ENGINE - NO.4 BEARING COMPARTMENT - INTRODUCE A NEW HEATSHIELDED NO.4 BEARING SCAVENGE  
TUBE ASSEMBLY - CATEGORY CODE 5 - MOD.ENG-72-0087

**V2500–ENG–72–0087**

# SERVICE BULLETIN

Location of No.4 Bearing Scavenge Tube Assembly  
Fig.1

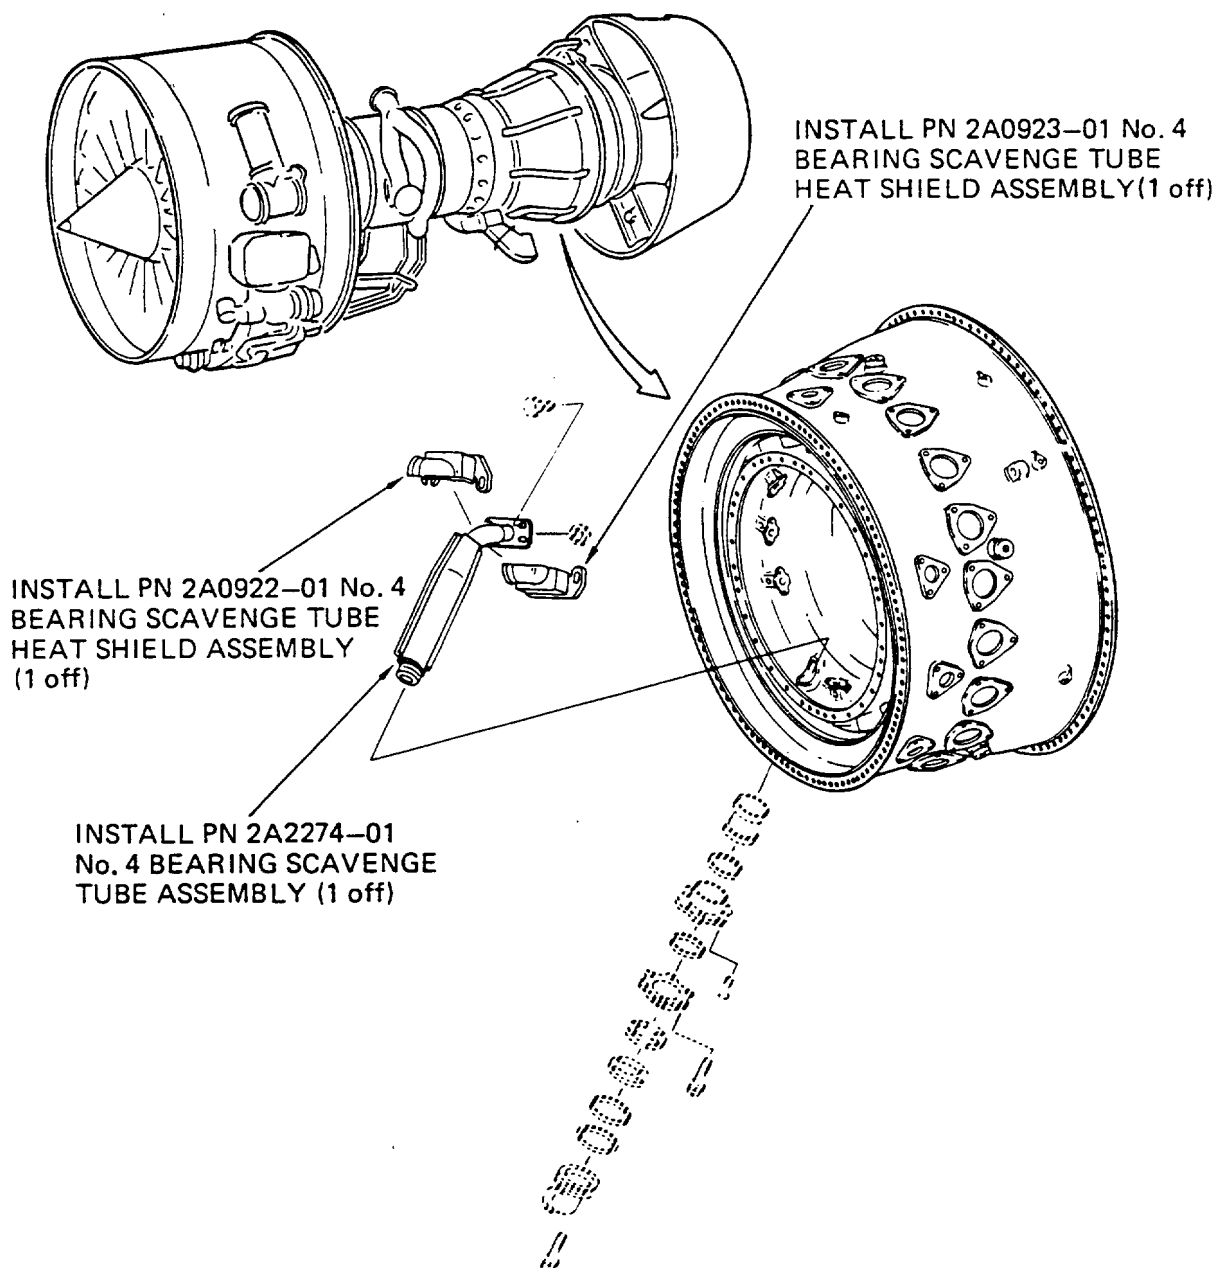
Rubbing of the Heatshield against the Diffuser Case Strut could cause the Heatshield to fragment.

Heatshield fragmentation occurred on some experimental engines. This happened because the original Tube Assembly had thin Heatshields and interference with the Diffuser Case Strut was possible under adverse tolerance conditions.

- (1) Provide a new NO.4 Bearing Heatshield Assembly which features an increased tube thickness, and increased Heat Shield thickness.
- (2) Restore the bolts on Heatshield halves that fit at the top of the No.4 Bearing Scavenge Tube Assembly.

- (2) Install the 2A2274-01 No.4 Bearing Scavenge Tube Assembly (1 off) by the approved procedure in Reference (2) Chapter/Section 72-42-00, Assembly. See Figure 1.
- (3) When the No.4 Bearing Housing is installed (by the approved procedure in Reference (2) Chapter/Section 72-42-00 Assembly) the Heat shields 2A0922-01 (1 off) and 2A0923-01 (1 off) will be installed.
